Advocating for Safe Cycling Throughout Durham Region

**RE: Multi Use Path (MUP) Victoria Street Whitby  
Calloway REIT (Whitby Shores) 601-619 Victoria Street W, Whitby, ON  
Durham Region Cycling Coalition Follow Up Letter**

## Garden / Rossland Shopping Plaza Whitby

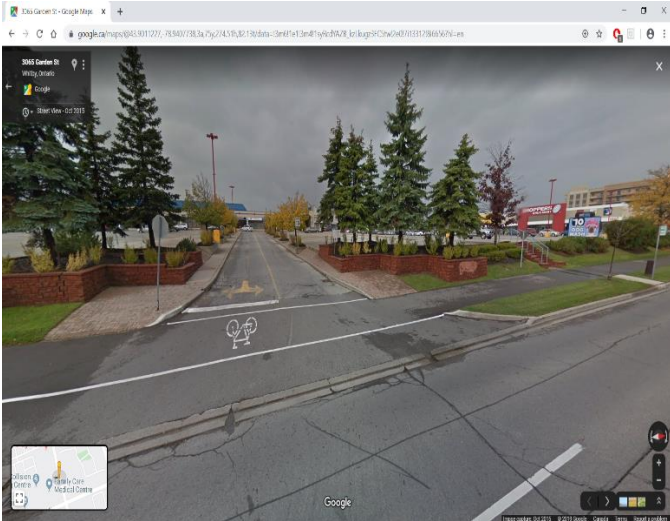
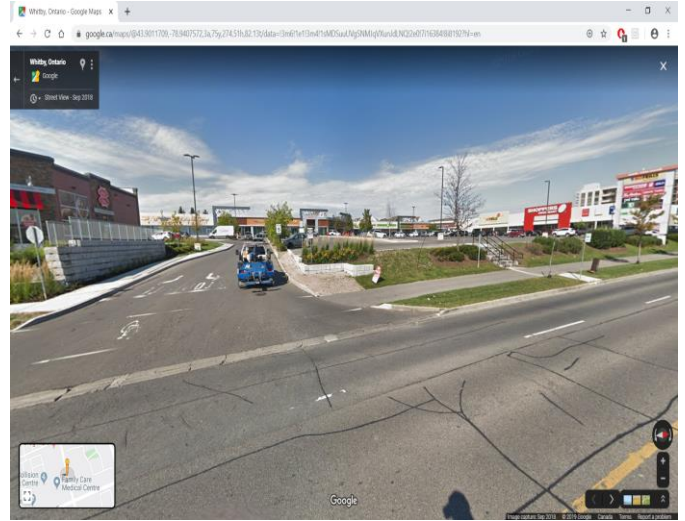
For your review and consideration, we have included a number of photos from a similar commercial plaza in Whitby located on the north west corner of Rossland Road and Garden Street. This plaza was experiencing similar challenges, that being an MUP fronting the property and safety blind spots from a past construction era pre MUP. Through no involvement from DRCC, we see the property owner has recently updated this entrance by reconfiguring walls and vegetation thus improving site lines for MUP users.

**Before Entrance with poor site lines**

**After Entrance with Improved site lines**

**Site Line View looking from vehicle on approach to MUP with retaining wall lowered and vegetation replaced.**
